Grandstream Networks, INC

Request for Class II Permissive Change

FCC ID: **YZZHT70X**

Original mainboard photo view

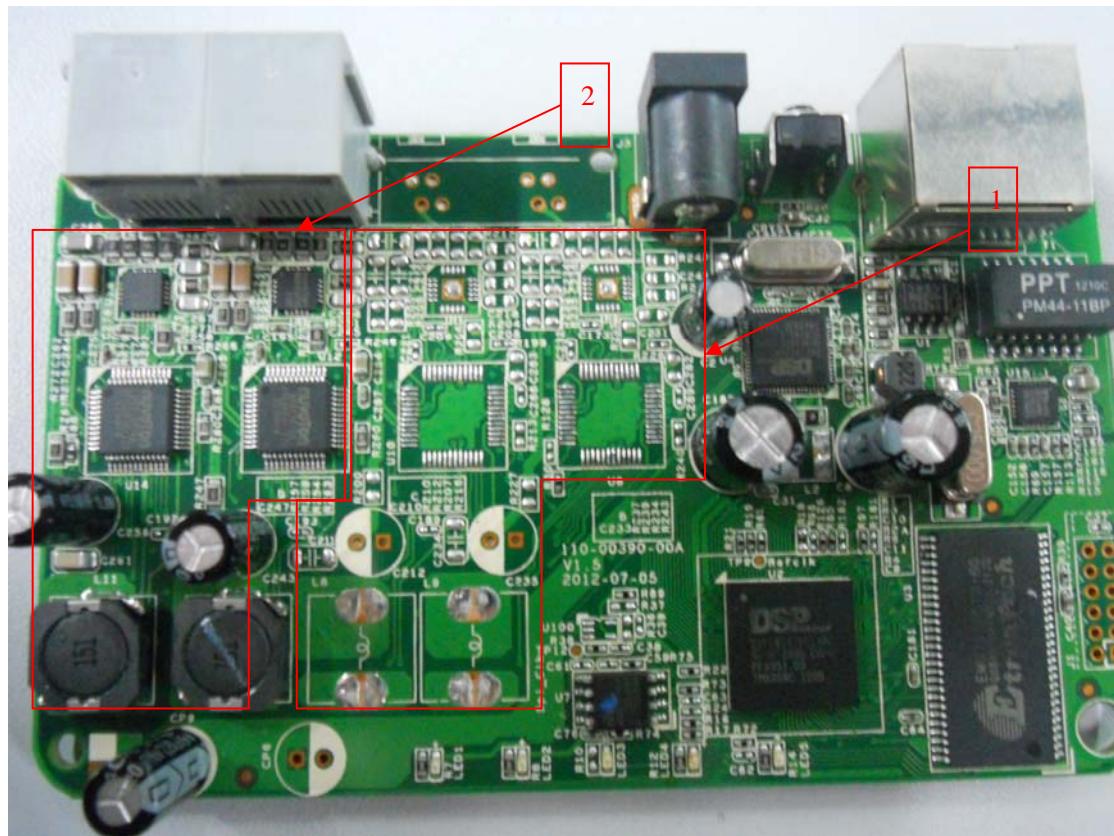
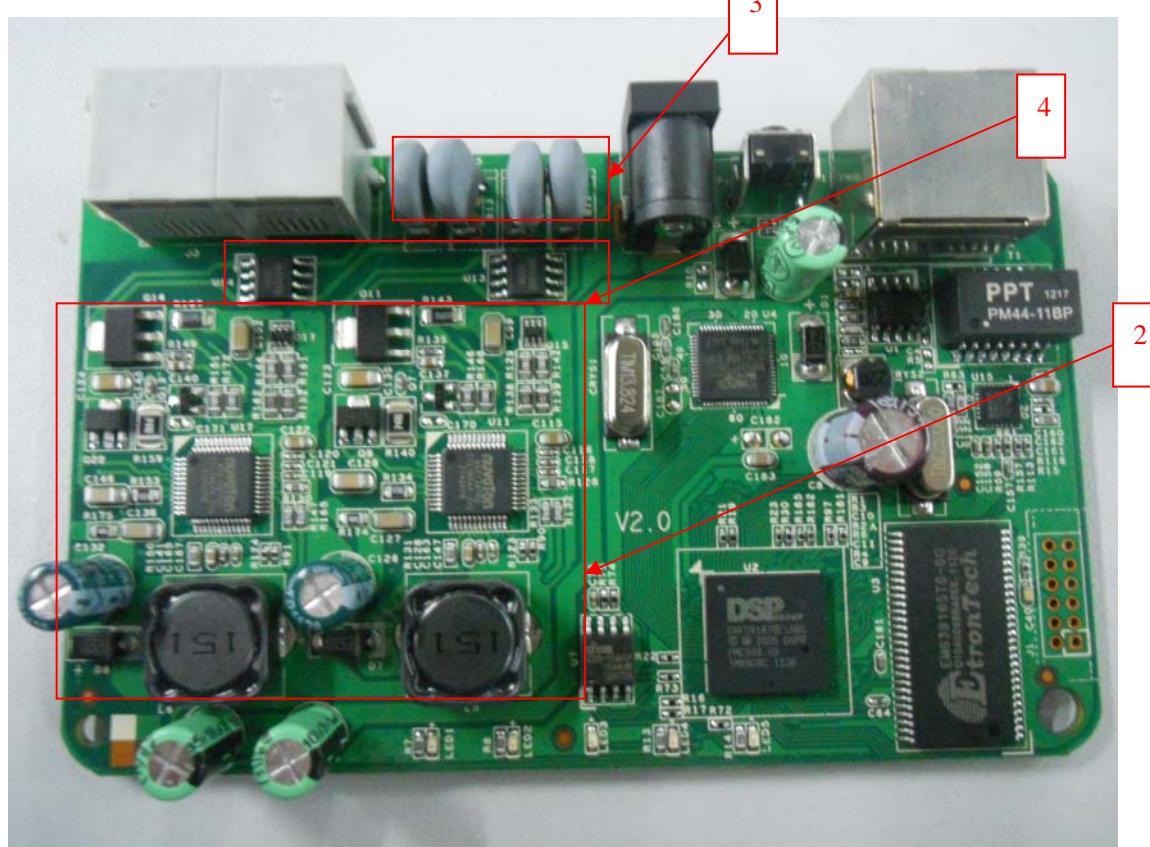
1. Deleted two Un-used SLIC Circuits (see Arrow 1) and replaced two integrated chips by discrete circuit (see Arrow2);
2. Added four 50 ohm PTCs (see Arrow 3) and two High Voltage protector ICs for TISP61089 (See Arrow 4).
3. Added a power adapter. it has the same input&output specification as original power adapter.
4. Changed brand of network transformer.
